Grand Ledge Construction
Board of Appeals

- V. NEW BUSINESS**
 - A. Appeal** – By the City of Grand Ledge of the Building Official’s decision on and interpretation of Michigan Mechanical Code Section 401.4(2).

Grand Ledge Iron Removal Plant Project – Intake Louver Code Review

City of Grand Ledge
 Eaton County, Michigan
Iron Removal Plant

SITE LAYOUT PLAN
 SCALE: 1" = 40'
 0 20 40 80
 NORTH

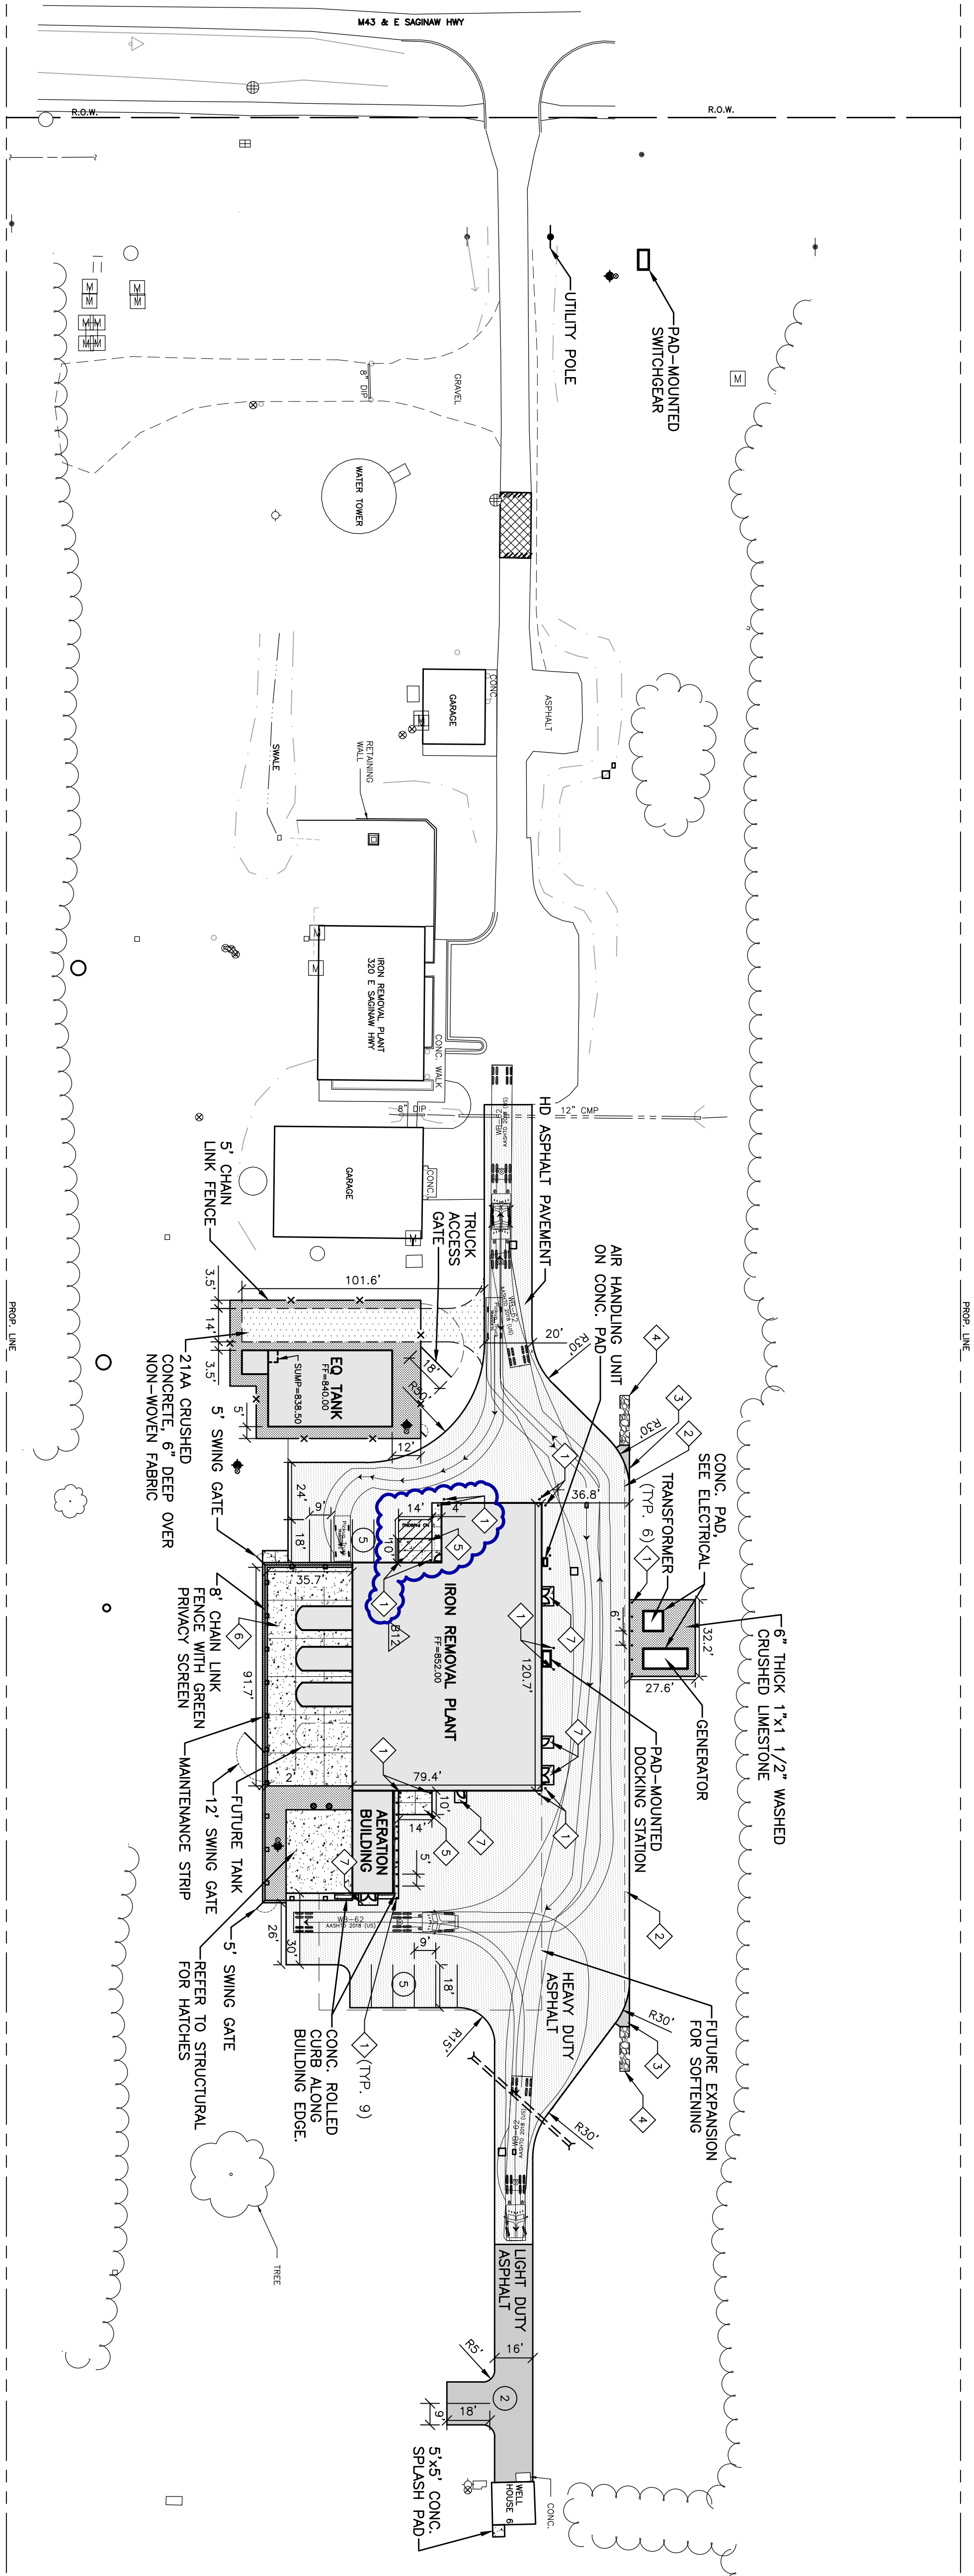
As indicated in my previous email and after my site visit with you I remain confident in our original alternate resolution. I have reviewed your proposal and I do not feel the signage and parking striping changes meet the life safety requirements the code suggests. The paved area next to the overhead door suggests a parking or drive area. **The signage and CO detection will remain mandatory.** Please let me know if you have any further questions or concerns, thanks.

The Building Official approves your alternative method (gas detection in lieu of approved separation between vehicles and fresh air inlet) with the caveat that the Fire Marshal will be invited to offer his concerns (if any) and the following conditions:

Bollards shall be employed in positions to discourage parking near the fresh air inlet (but are not required where they would impede use of the adjacent OH door). The idea is to keep as much separation as possible without obstructing use of the door.

In an effort to address your concern about a vehicular parking/idling in front of the overhead door, the City will paint pavement markings in front of the overhead door to indicate the area as a No-Parking space, including striping on the pavement and apron near the intake louver. The iron removal plant facility entrance is gated with access only allowed for City staff or approved visitors; it is not accessible to the public. This will allow the City to control access to the area in question.

Attached is a plan showing the no parking striping. We believe we have addressed your concerns and that the plain language of Section 401.4 is satisfied.

In an effort to address the concern about a vehicular parking/idling in front of the overhead door, the City proposed to paint pavement markings in front of the overhead door to indicate the area as a No-Parking space, including striping on the pavement and apron near the intake louver. The iron removal plant facility entrance is gated with access only allowed for City staff or approved visitors; it is not accessible to the public. This will allow the City to control access to the area in question.

Attached is a plan showing the no parking striping. The Dewitt Township Code officials rejected this proposed plan and are calling for installation of monitoring and alarms designated for enclosed parking garage structures. The City would like to appeal this determination.
